**City of Woodburn**  
**Community Development Dept.**

**Date:** January 26, 2024  
**To:** Cole Grube, Project Engineer  
**Cc:** Roy Hankins, P.E., Emerio Design, LLC  
**From:** Colin Cortes, AICP, CNU-A, Senior Planner *CC*  
**Subject:** **Planning Division review comments on 2<sup>nd</sup> submittal January 3 of civil engineering plans for Mill Creek Meadows PUD**

The developer's civil engineering plan (CEP) review set is Emerio Design project number 0082-008 dated December 2023, the 2<sup>nd</sup> submittal / 1<sup>st</sup> revised submittal.

Sheet 40 "Street Signage Striping and Street Tree Plan" (December 2023)

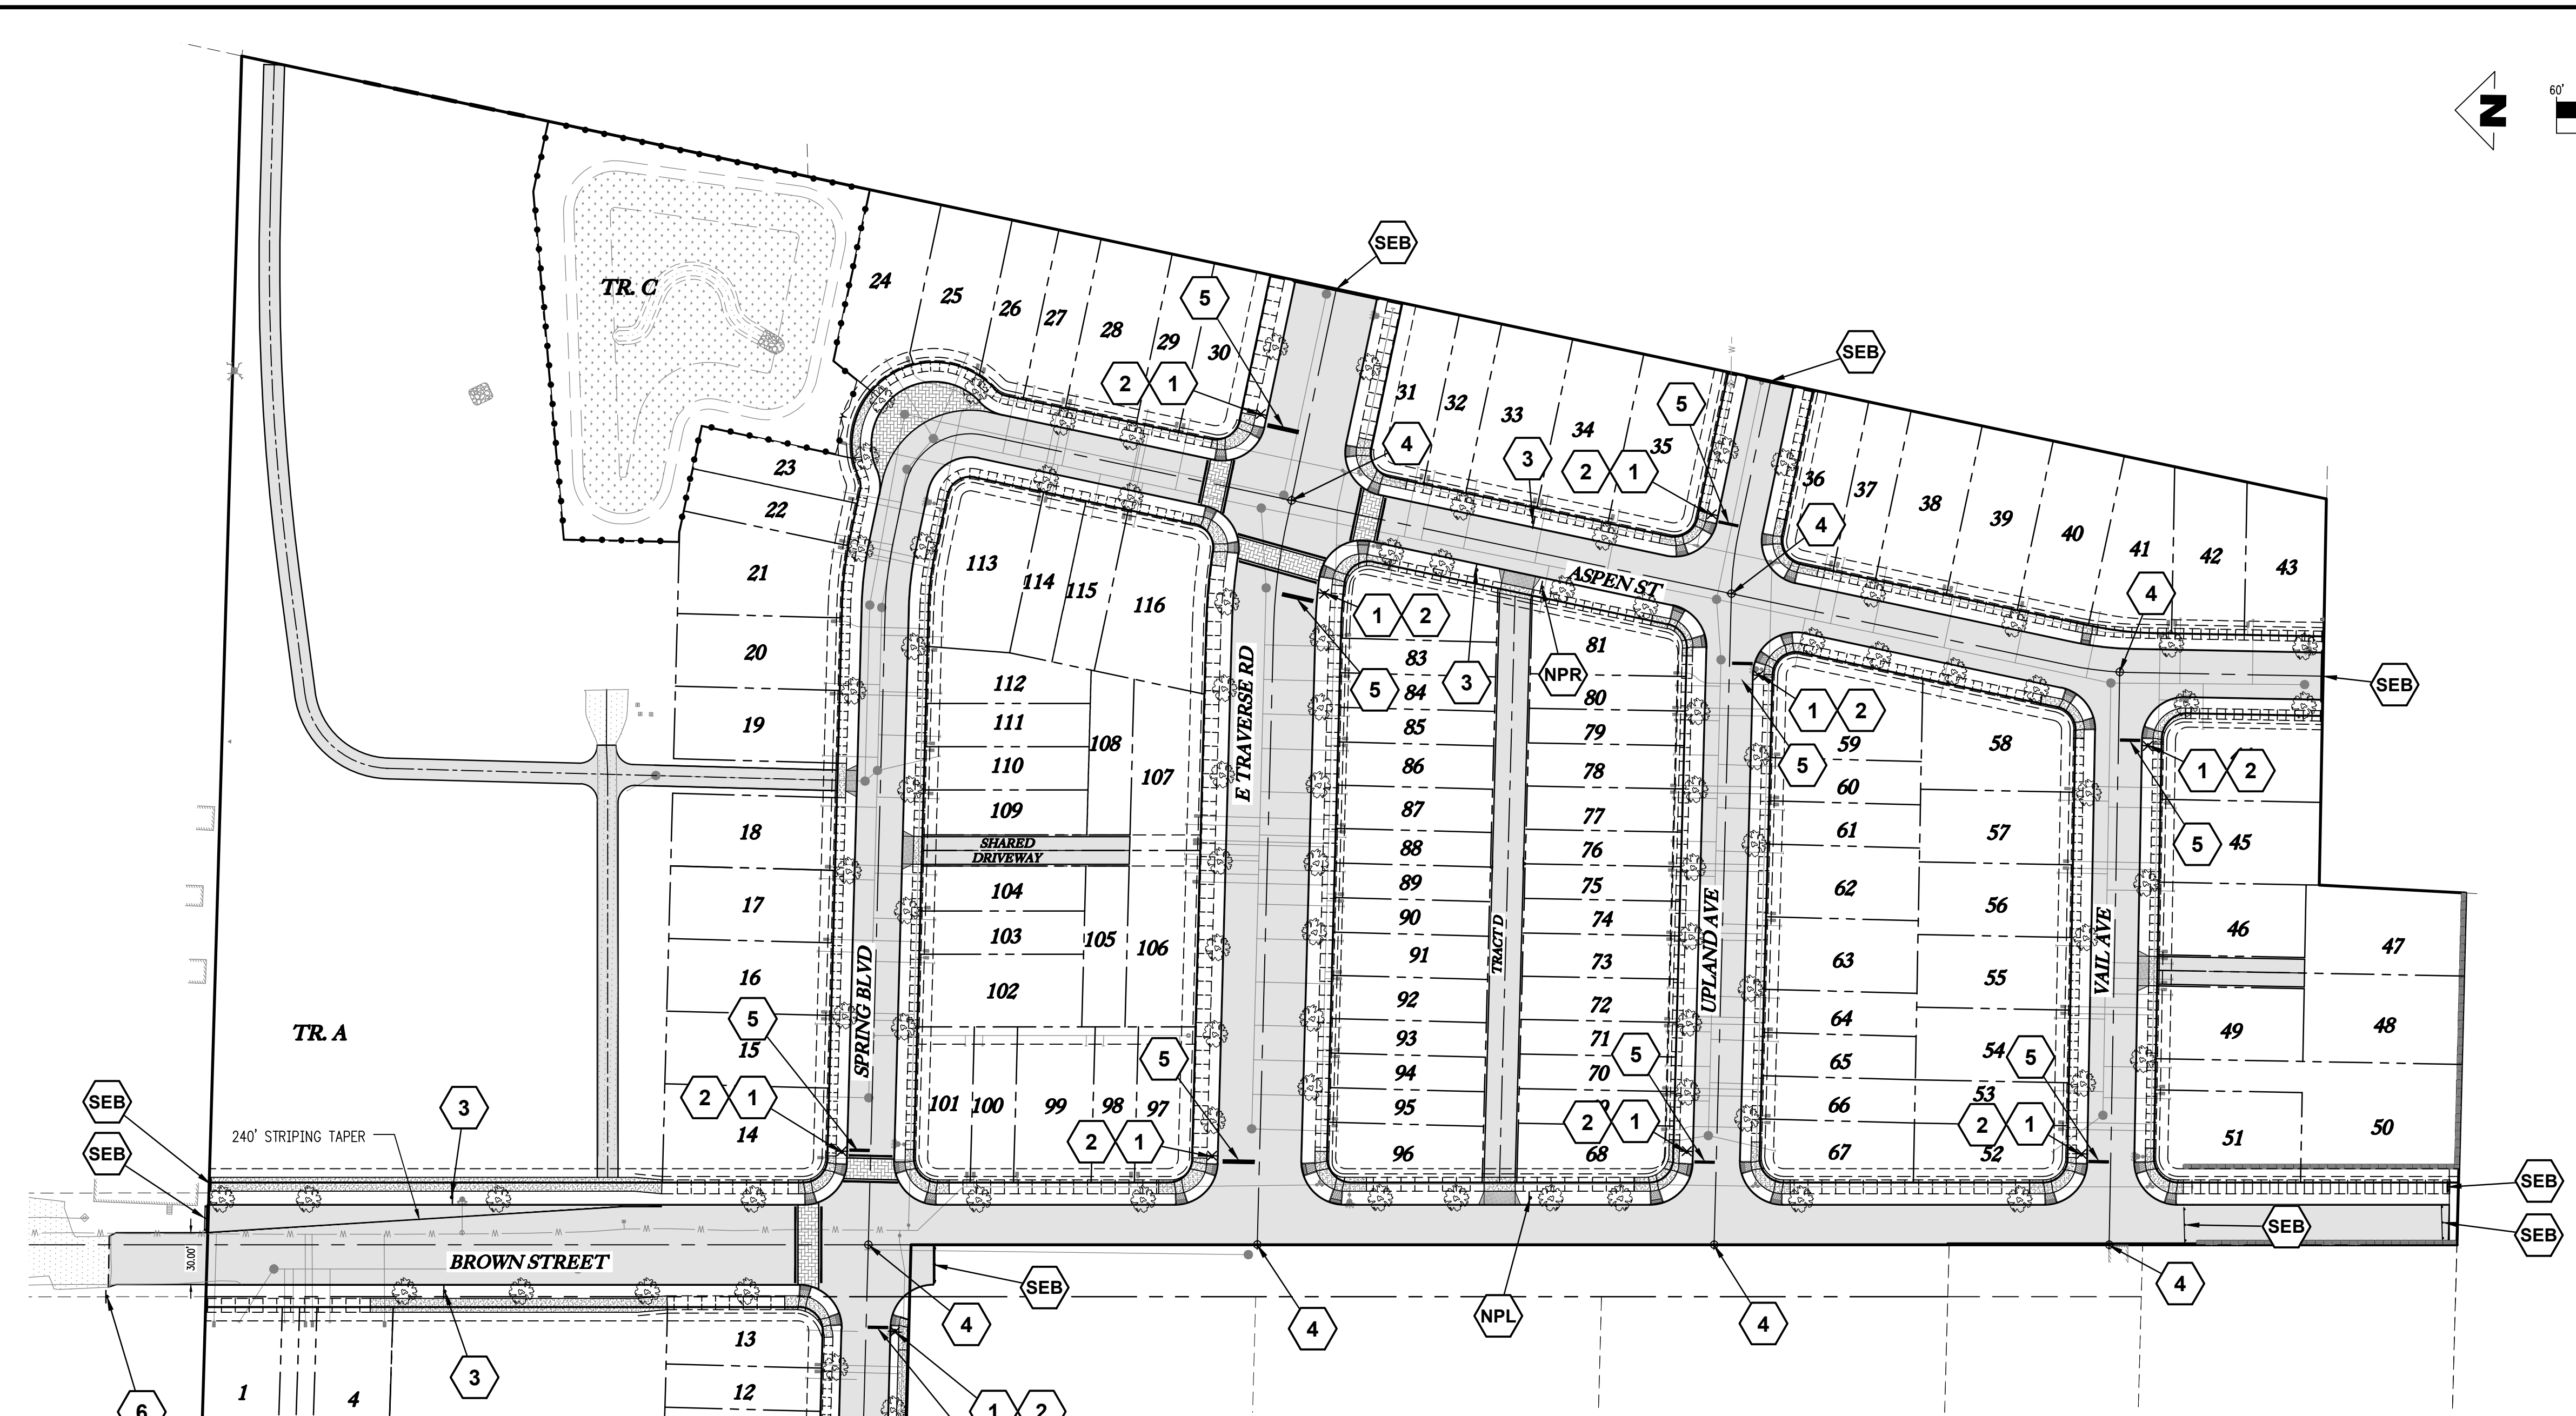
*1. Number: The minimum number equal to 1 per 30 ft of block face isn't met. At minimum, revise Sheet 39 Street Signage Striping and Street Tree Plan to correct along the whole of the private alley block (E. Traverse/Aspen/Upland/Brown), all of the remainder of E. Traverse Road, and Brown Street along Tracts A & B.*

*3. Driveways: Revise Sheet 39 to illustrate proposed driveway locations with aprons that conform with final decision Attachment 202, Part B, Table 202B maximum widths.*

The applicant's response memo states, "Driveway final location will be determined with home construction. Proposed driveways will conform to width standards."

Deferral would complicate addressing item H.4 below because driveways are a major constraint on street tree placements.

Sheet 40, Tree Planting Note 1 indicates, "... See landscaping plan for spacing and plant list of street trees", but there is no such sheet. The applicant's response letter states, "To be taken care of by landscape architect".

- TREE LOCATION SHOWN FOR REFERENCE ONLY. SEE LANDSCAPING PLAN FOR SPACING AND PLANT LIST OF STREET TREES.

For this item, illustrate scaled placements of driveway aprons for each lot and tract that are at least conceptual.

There's no other review stage to defer a street tree plan. The civil engineering plan review purpose is to establish the details of the public improvements that the developer is to construct or install and how as well as identify the plan set that is the basis for staff inspections. Demonstrate conformance.

Per the final decision fee schedule (Attachment 203, Table 203B), row "Street improvements: Street tree fee in-lieu", the developer can buy out of a number of street trees. When submitting a street tree plan per this Item H.4, indicate what block faces have what deficits, if any, tabulate and total the deficits, and expect to pay a total street tree fee in-lieu (through the Planning Division) prior to final plat approval.
